UNITED STATES
NUCLEAR REGULATORY COMMISSION
WASHINGTON, D. C. 20555

ATTACHMENT TO LICENSE AMENDMENTS

AMENDMENT NO. 86 TO FACILITY OPERATING LICENSE NO. DPR-32

SAFETY EVALUATION BY THE OFFICE OF NUCLEAR REACTOR REGULATION
RELATED TO AMENDMENT NO. 86 TO FACILITY OPERATING LICENSE NO. DPR-32
AND AMENDMENT NO. 87 TO FACILITY OPERATING LICENSE NO. DPR-37
VIRGINIA ELECTRIC AND POWER COMPANY
SURRY POWER STATION, UNIT NOS. 1 AND 2
DOCKET NOS. 50-280 AND 50-281

FIGURE 2.1-1 REACTOR CORE THERMAL & HYDRAULIC SAFETY LIMITS-
THREE LOOP OPERATION, 100% FLOW

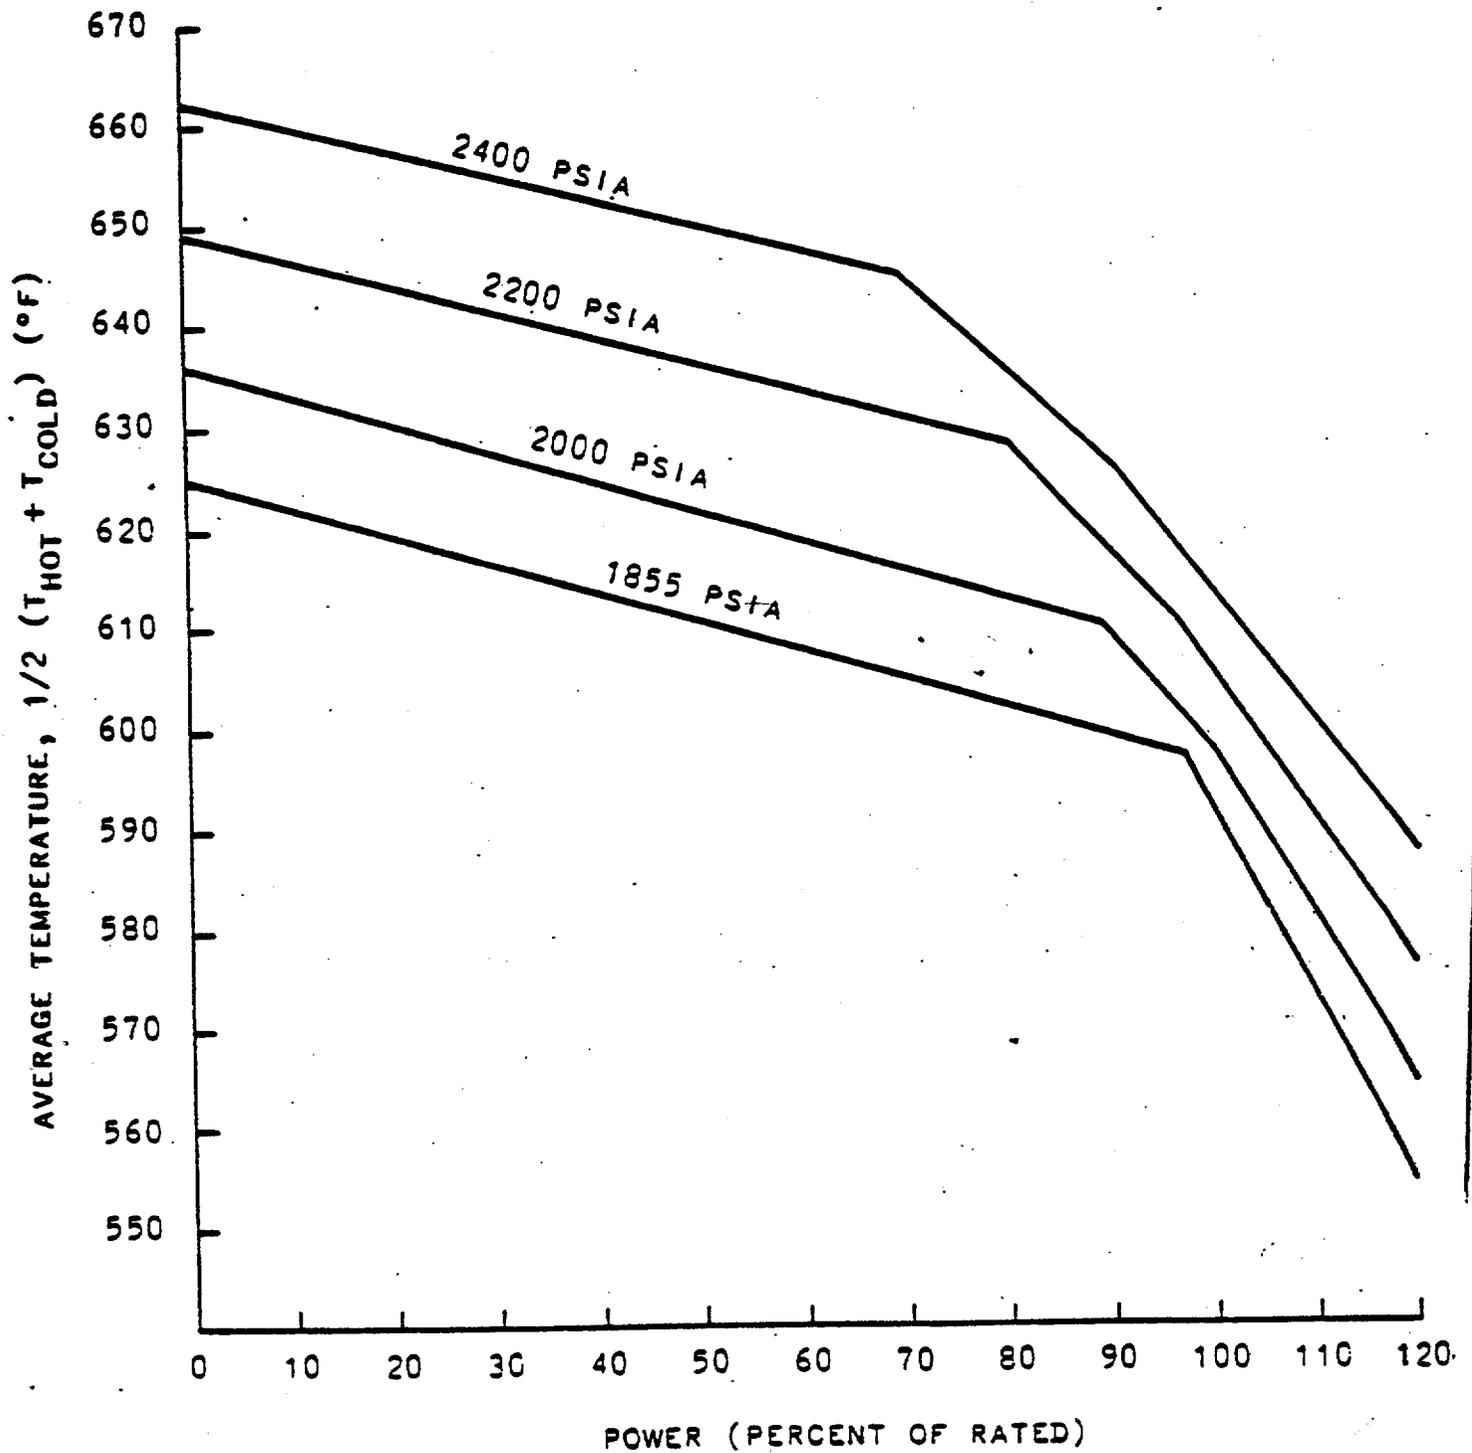
These amendments revise the Technical Specifications to restore the core thermal limits and overtemperature and overpower ΔT setpoints to values consistent with 100% of thermal design flow.

The curves of TS Figure 2.1-1 which show the allowable power level decreasing with increasing temperature at selected pressures for constant flow (three loop operation) represent limits equal to, or more conservative than, the loci of points of thermal power, coolant system average temperature, and coolant system pressure for which the DNB ratio is equal to 1.30 or the average enthalpy at the exit of the core is equal to the saturation value. The area where clad integrity is assured is below these lines. The temperature limits are considerably more conservative than would be required if they were based upon a minimum DNB ratio of 1.30 alone but are such that the plant conditions required to violate the limits are precluded by the self-actuated safety valves on the steam generators. The three loop operation safety limit curve has been revised to allow for heat flux peaking effects due to fuel densification and to apply to 100% of design flow. The effects of rod bowing are also considered in the DNBR analyses.
